CONSERVATION COMMISSION AGENDA

Date: May 4, 2021

I. WETLANDS DECISIONS

59 Bennetts Road

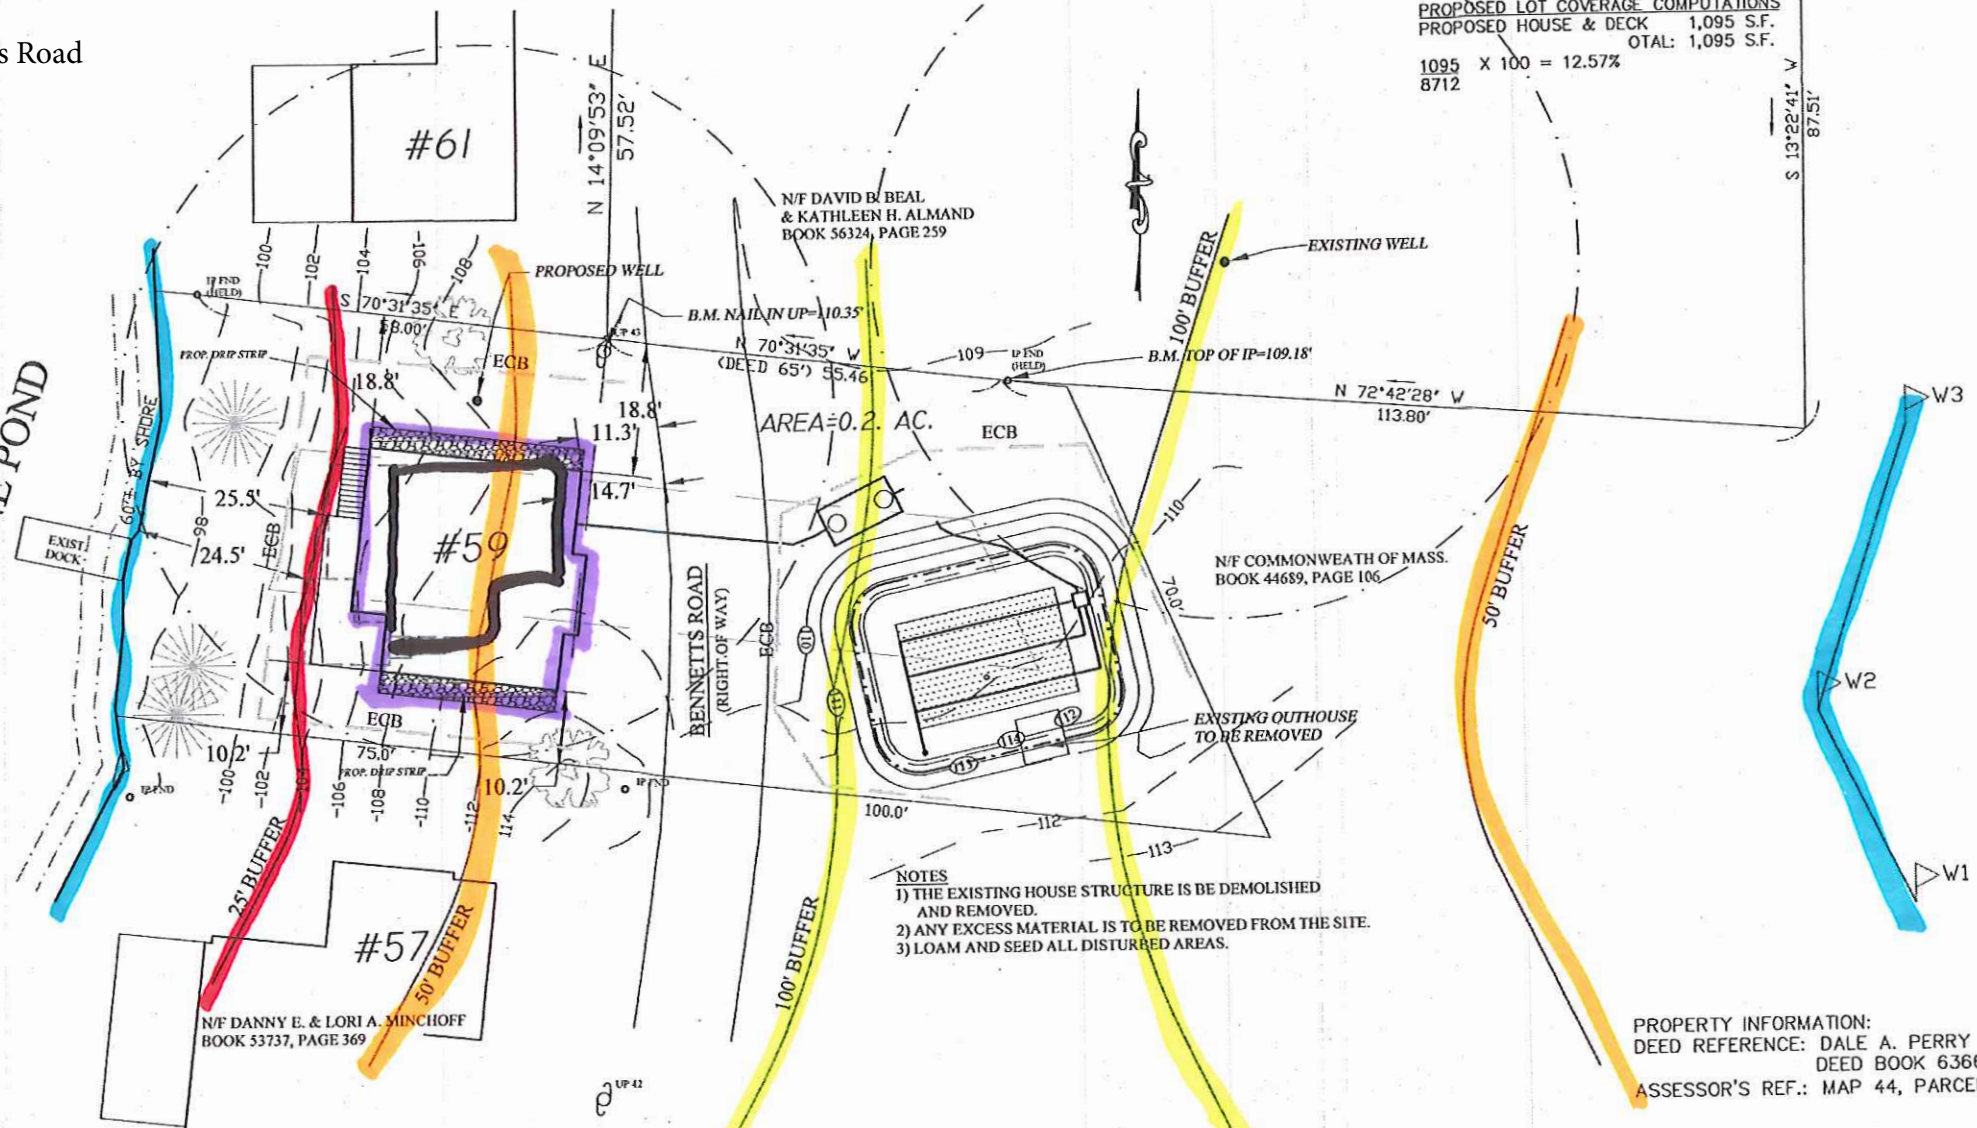
- Site plan has been revised since original submittal to include abutter's well and BVW located to the east on DFW land which both were not shown.
 - Notes from site visit:

- Existing cottage is located on top of a steep drop off which has tree stump roots holding embankment. It is unclear from the plan if this area will be altered/excavated.

- Native vegetation along existing cottage (mountain laurel) is within the LOW and would appear to need to be removed.
 - It would appear that the large deciduous trees and surrounding vegetated areas will be impacted by the project. The application notes that no trees are to be removed, however, they are close to the LOW and staff would anticipate that the oak on the southern boundary will most likely be impacted when the foundation is dug and requested to be removed during work and the installation of the well will affect that tree and associated vegetation.

- No parking noted on the plan.
 - Structure will be located further from the lake however the new structure is still located within the 50 foot No New Structure Setback. This would require a waiver from the board to construct the new structure.

- The applicant is proposing stormwater infiltration for roof runoff. The representative should confirm that all roofs will discharge to the drip strips. Does not appear that stormwater BMPs are proposed beneath the deck which is proposed within 25.5 FT of the lake.

- New structure will be an increase of the overall square footage on the site.
 - It is unclear if grading will be required. What is proposed for ground cover within disturbed areas?

- Where will work stockpiling occur?
 - Appears that a variance from BOH will be required for the septic system as it is proposed within the setback to the abutter's well. A request for a variance should be submitted as if it is not approved then the system and project cannot be constructed.

- Staff Recommendations: Continue the public hearing as there is no DEP File #. Staff also recommend that an application for the BOH variance is submitted and reviewed prior to the Commission voting on this project. Staff recommend that options are explored to minimize disturbance on the site and to allow for plan revisions if requested. Hearing should be continued to at least June 1, 2021 to provide sufficient time to address these comments unless they can be addressed by May 11, 2021 for the May 18, 2021 meeting.

PROPOSED SITE PLAN
NEW CONSTRUCTION
VIRGIL & KIM VAN GERVEN
28 CAMP ROAD
STURBRIDGE MA
13 APRIL 2021

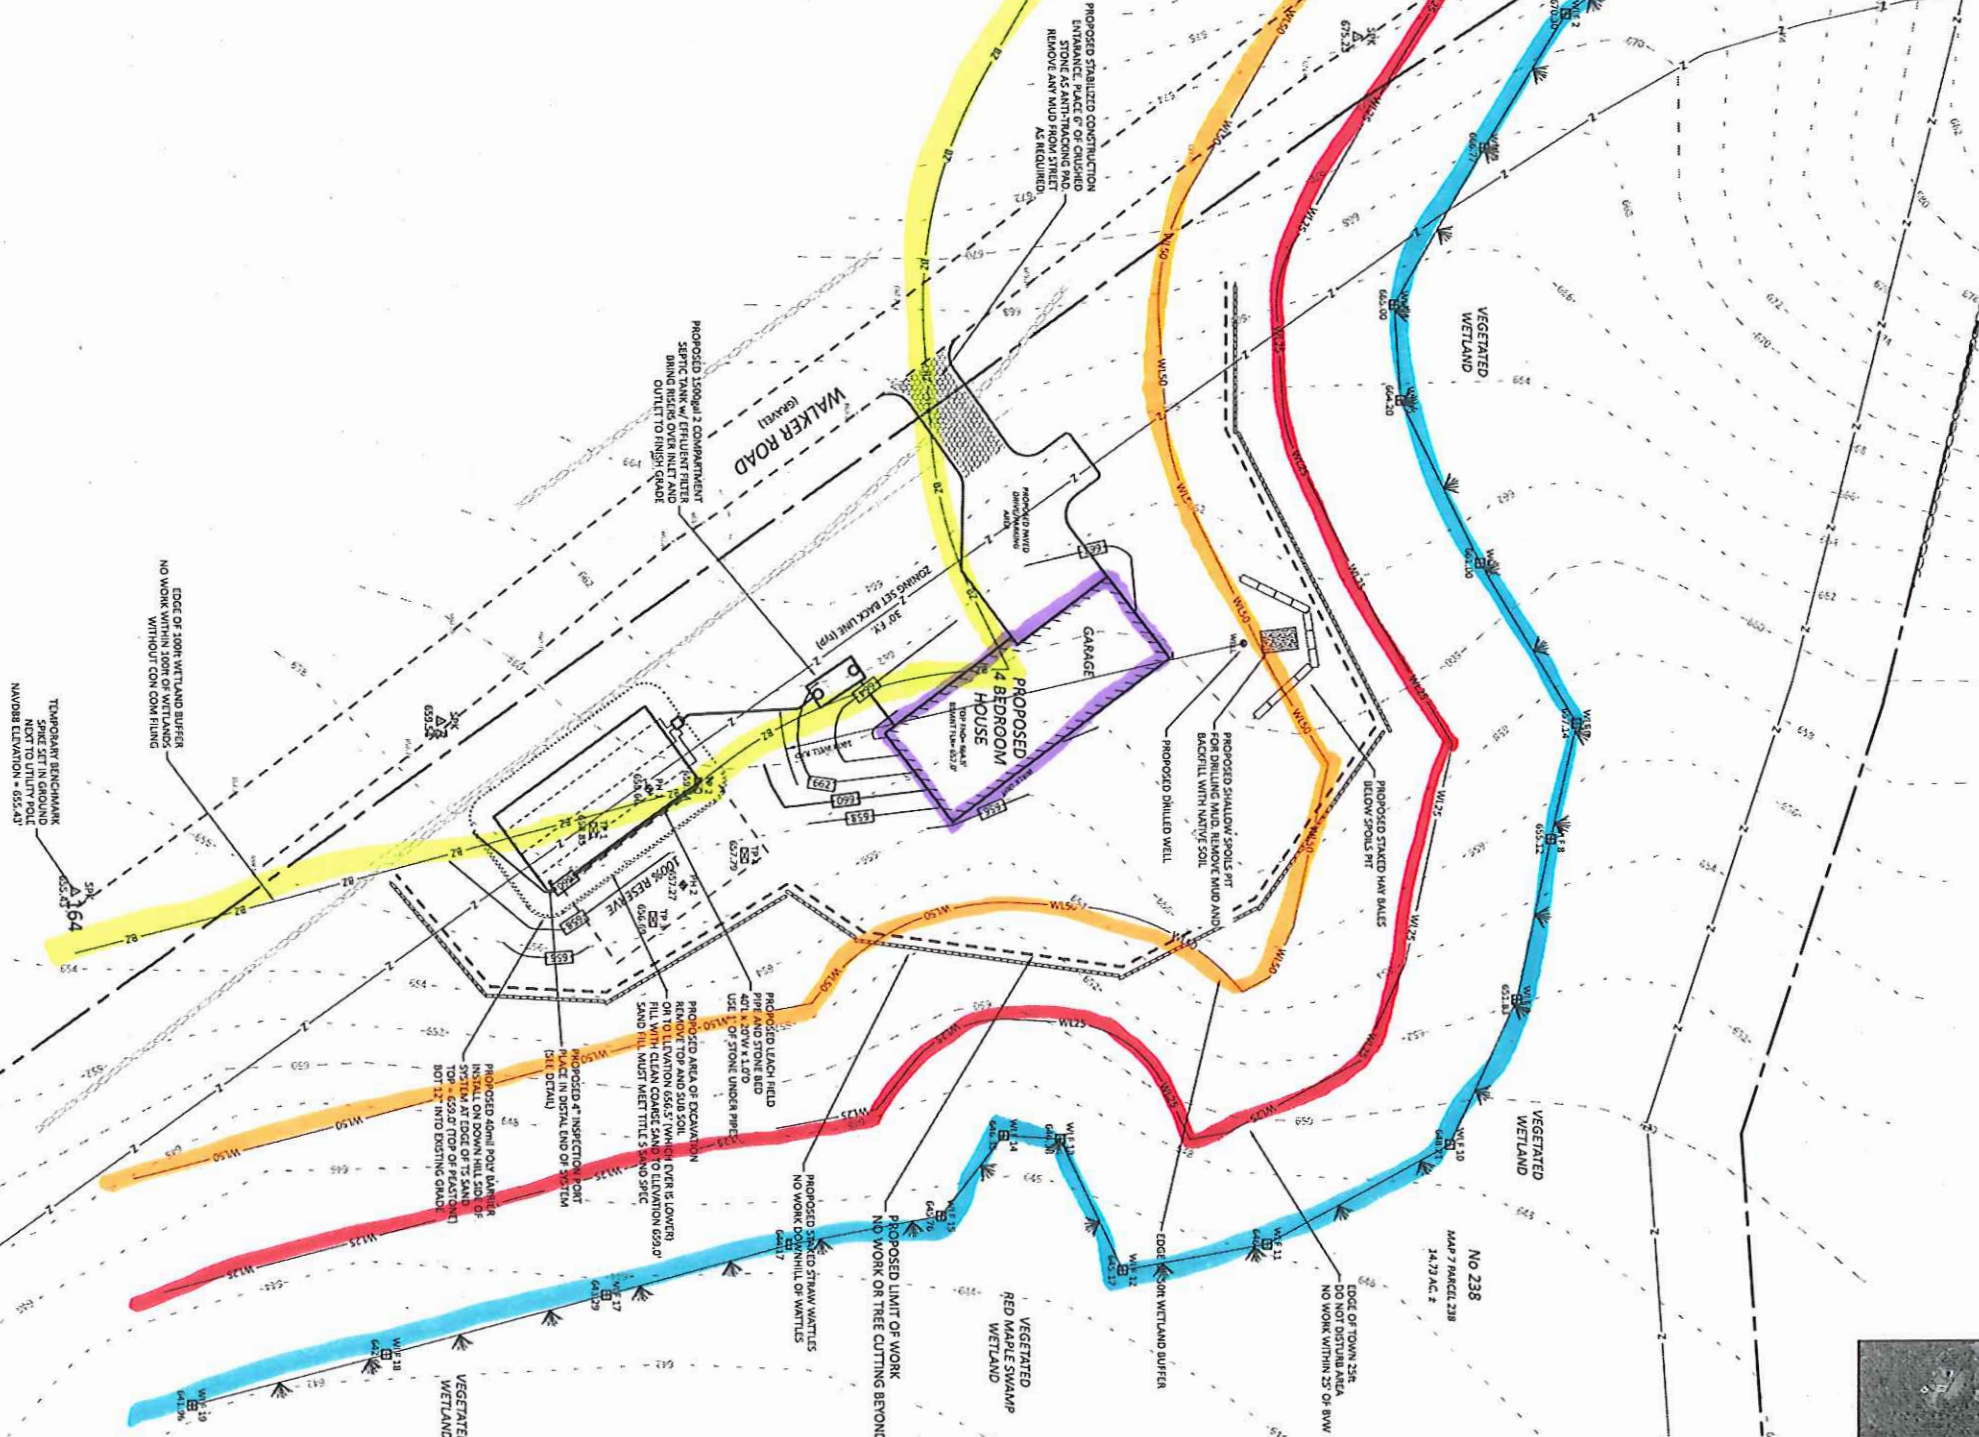
- Project as shown within the buffer zone to Bank, BVW and LUW. Additional work may be located within or adjacent to other resource areas. Properties contain two identified potential vernal pools.

- Application does not include all work including the proposed driveway from Route 20 and additional work which has been completed which is to be restored. These items all need to be shown on the plan including restoration details.

- Application does not include BVW data sheets or review by wetland scientist. Site must be reviewed and all wetlands within 200 feet of all proposed work must be shown.

- No BMPs shown for roof runoff and/or driveway runoff infiltration. Driveway from Camp Rd is steep and primarily drains towards the resource areas.
 - Plans must also include all buffer zones, 25', 50' 100' & 200'.

- Site visit notes:
 - Additional clearing noted on ACOE land within 100 feet of the lake– which includes mature tree, shrub and sapling removal.
 - Staff Recommendations: Continue the public hearing as a DEP File # has not been issued for wetland delineation and for plan revisions. Staff recommend that a plan is developed to restore areas of disturbance. Hearing should be continued to at least June 1, 2021 to provide the project team time to address comments and revise the submittal.

104 Westwood Drive

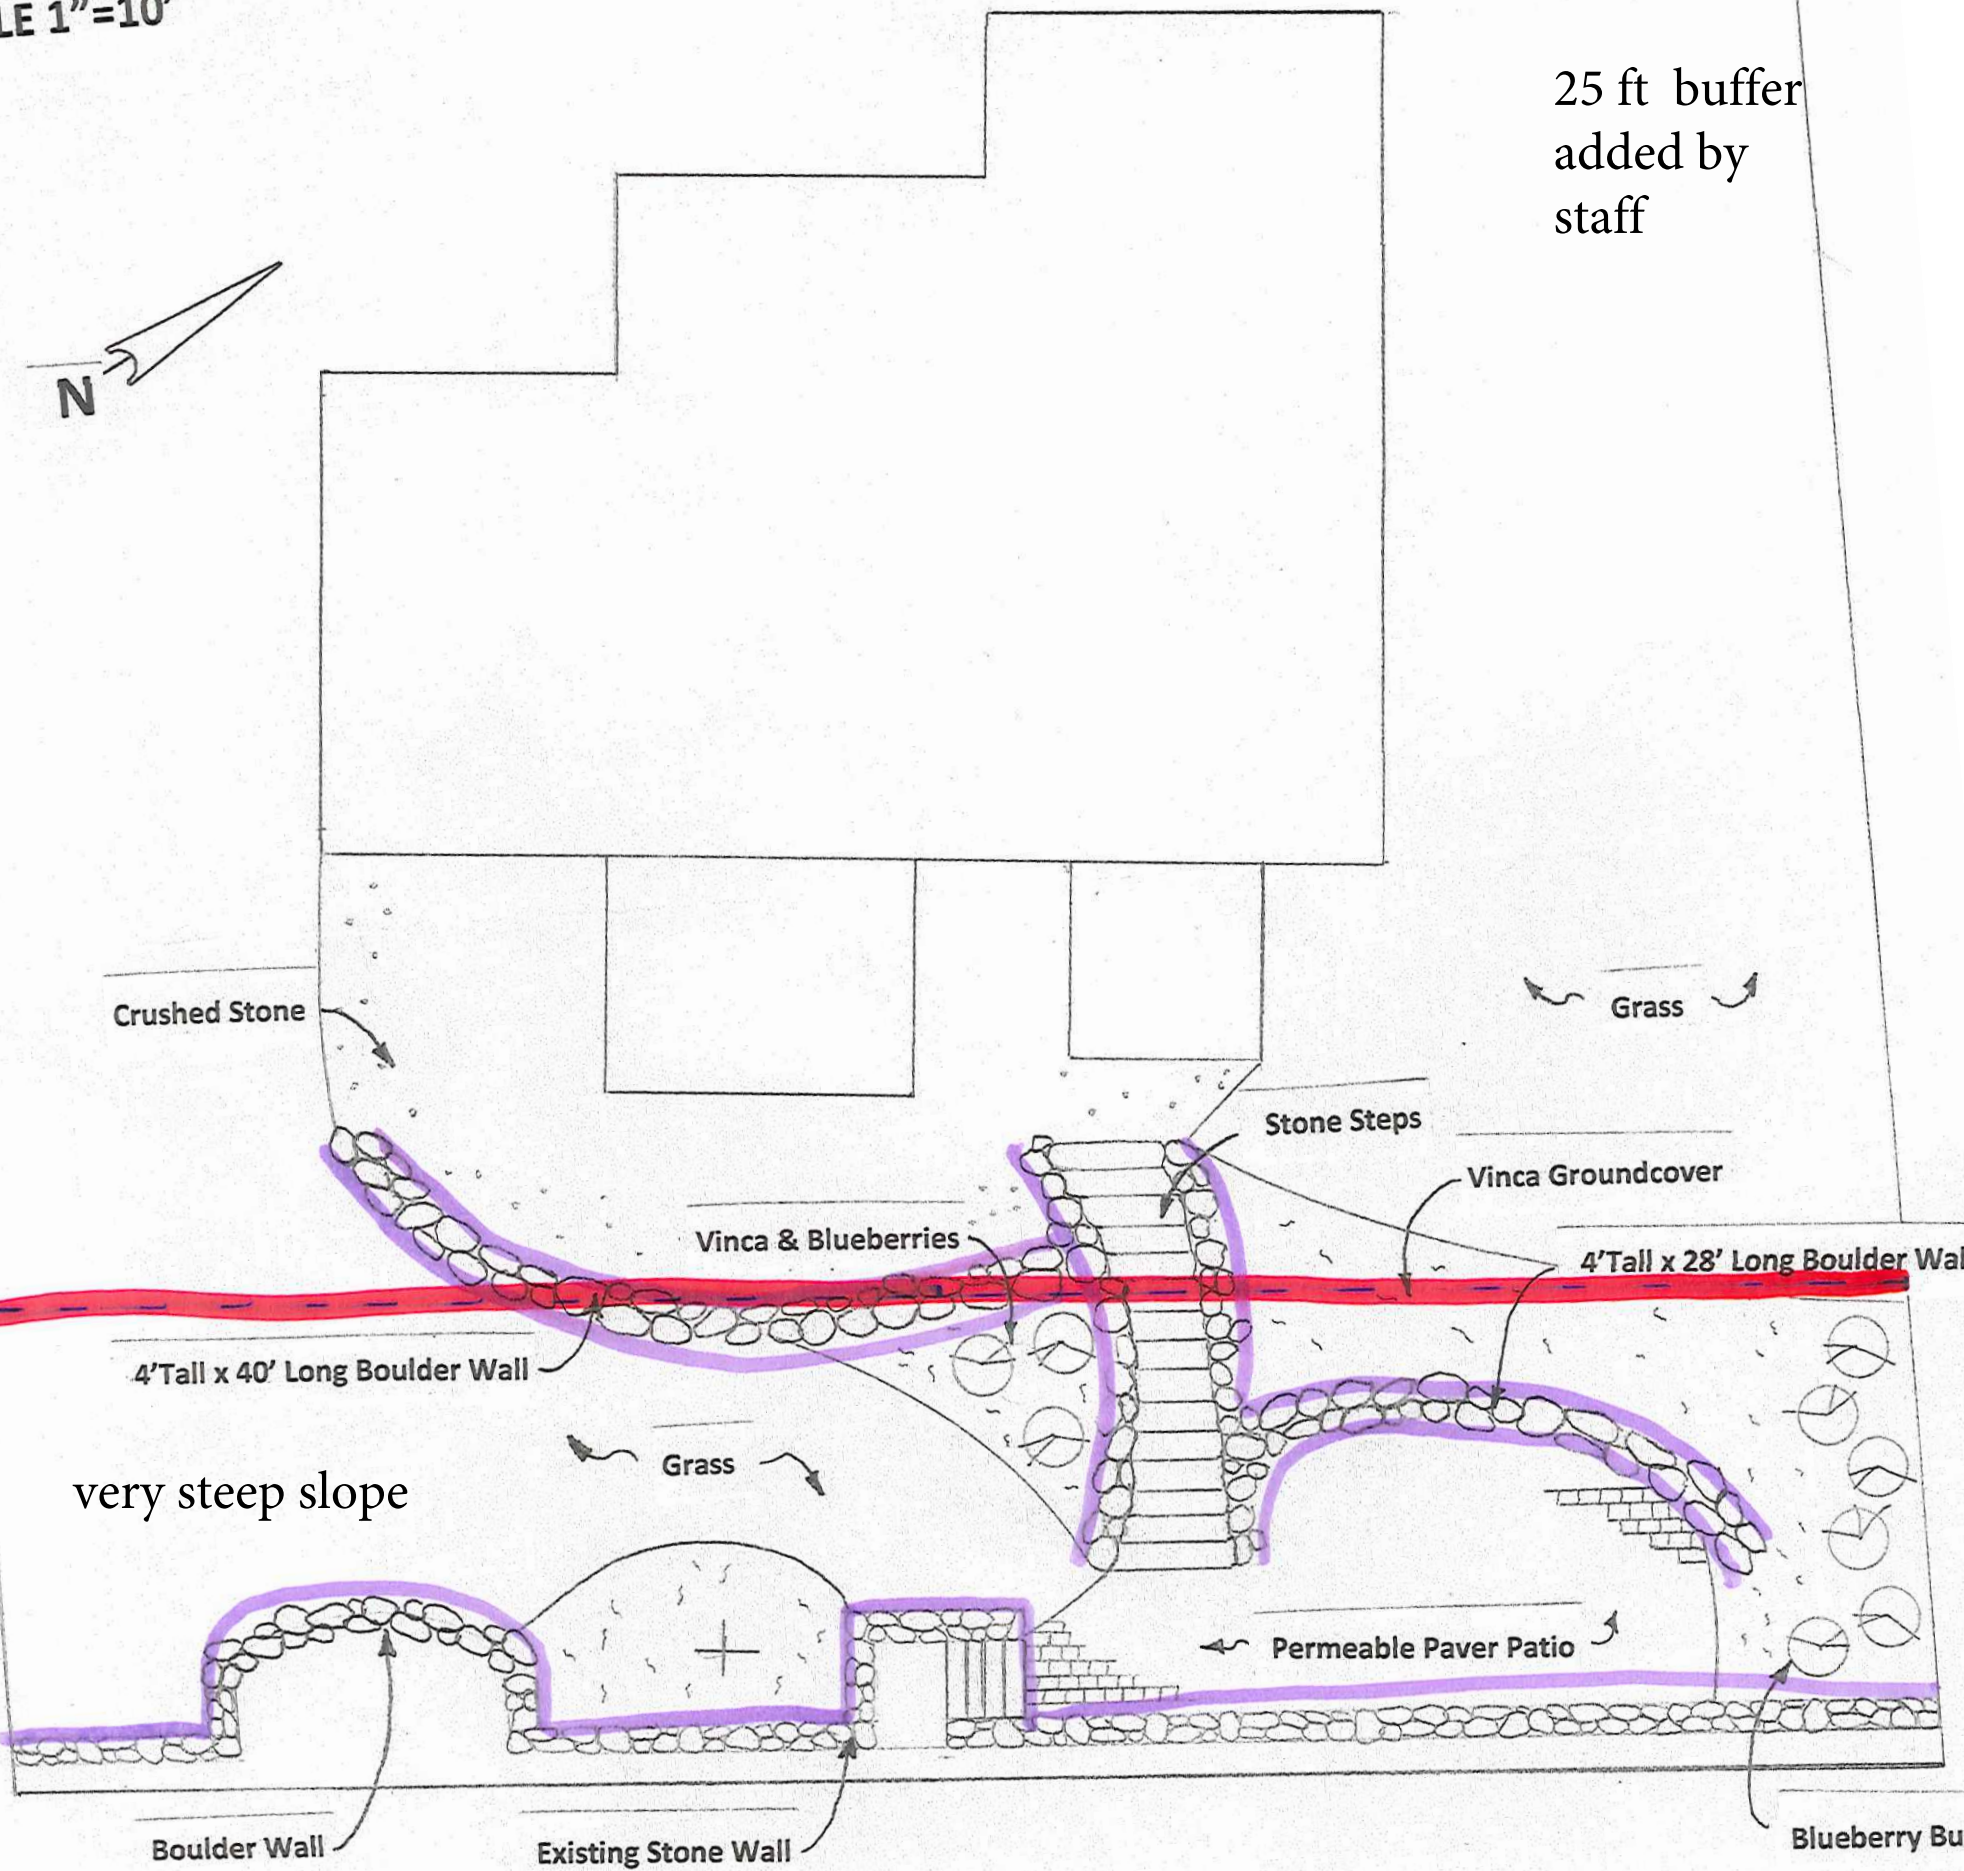
- Appears that work has been recently completed on the shoreline stone retaining wall and a dock has been installed. Staff inquired about the wall and were provided with photos showing that a wall existed and that a seasonal float dock was previously in place The wall has been repaired within the past few years and a new seasonal dock has been installed.

- Staff have discussed with the representative revisions to be made and submitted to cover the additional work. Application should be revised to include any unpermitted work which has been done and must meet performance standards for Bank and LUW. Dock requires BOS-Harbormaster approval as is seasonal.

- Project appears to be in Bordering Land Subject to Flooding (BLSF) and impact is not quantified in the NOI or narrative. The applicant must also demonstrate that flood waters will not be deflected to abutters.

- Site plan should include buffer zones (25 & 50ft from top of Bank). Options should be explored to minimize work within the 25 Ft. No Disturb Setback and for shoreline wall and/or show alternative analysis for where proposed.

- Staff Recommendations: Continue the public hearing as a DEP File # has not been issued and to address the comments to May 18, 2021 or June 1, 2021 if additional time is needed.
